RE: PETITION NO. 1497 - Bloom Energy Corporation petition for a declaratory ruling, pursuant to Connecticut General Statutes §4-176 and §16-50k, for the proposed construction, maintenance and operation of a customer-side 2-megawatt fuel cell facility and associated equipment to be located at Bridgeport Hospital, 267 Grant Street, Bridgeport, Connecticut.

**Petition No. 1497
Bloom Energy Corporation
Bridgeport Hospital
267 Grant Street, Bridgeport
Interrogatories**

Attachment 1: Site Plan Detail for Screening Fence

6' HIGH SCREENING FENCE DETAIL

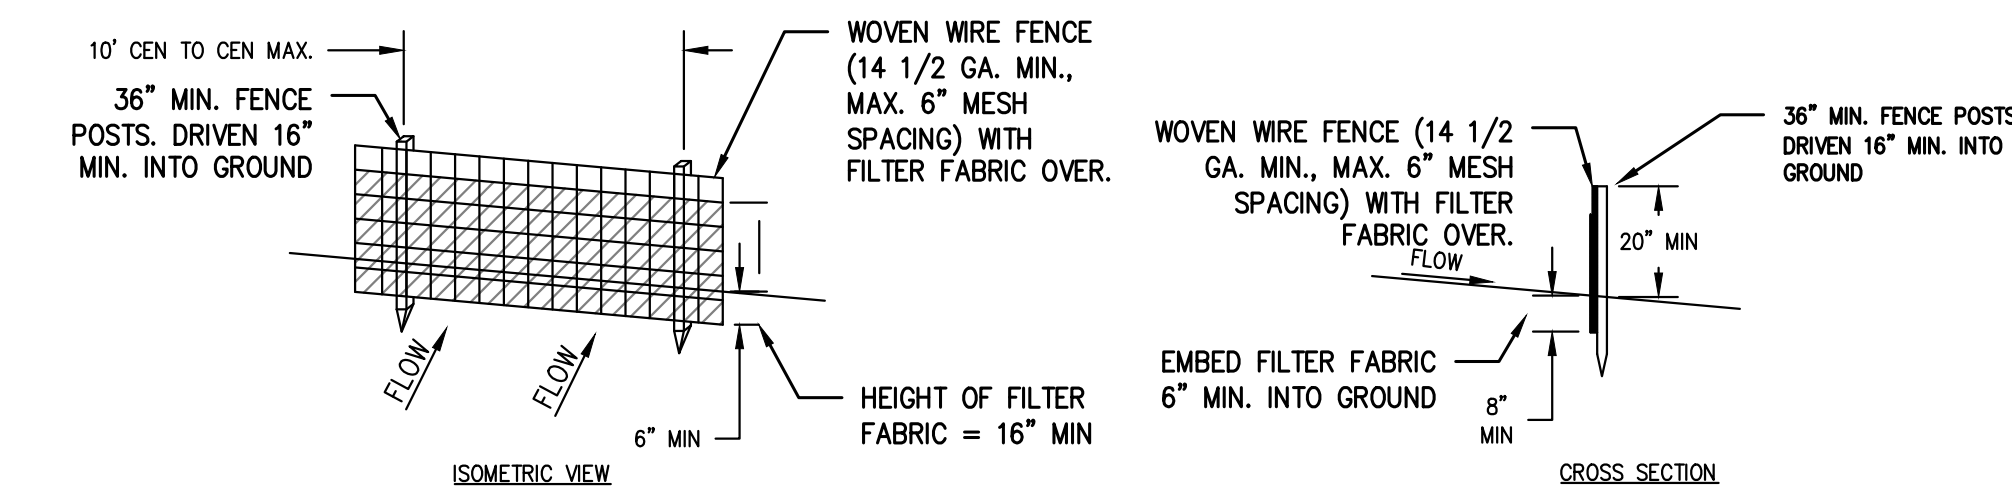
5. Referring to the Site Plan, provide a detail or a photograph of the "screening fence."

6. Due to the fuel cell location adjacent to parking lot spaces, are bollards or other vehicle impact protection measures proposed? If yes, revise the site plan to include such measure(s). If no, is the proposed screening fence reinforced to serve as a vehicle impact protection measure?

Response: Please see Attachment # 1 site plan detail for screening fence.

Response: No other vehicle impact protections are proposed. The systems are sufficiently set back greater than 3' from a raised curb, which acts as a means to deflect or deter vehicles from further accidental impact with the fuel cells themselves. The proposed screening fence includes steel fence posts and concrete footings, which act as a further deterrent.
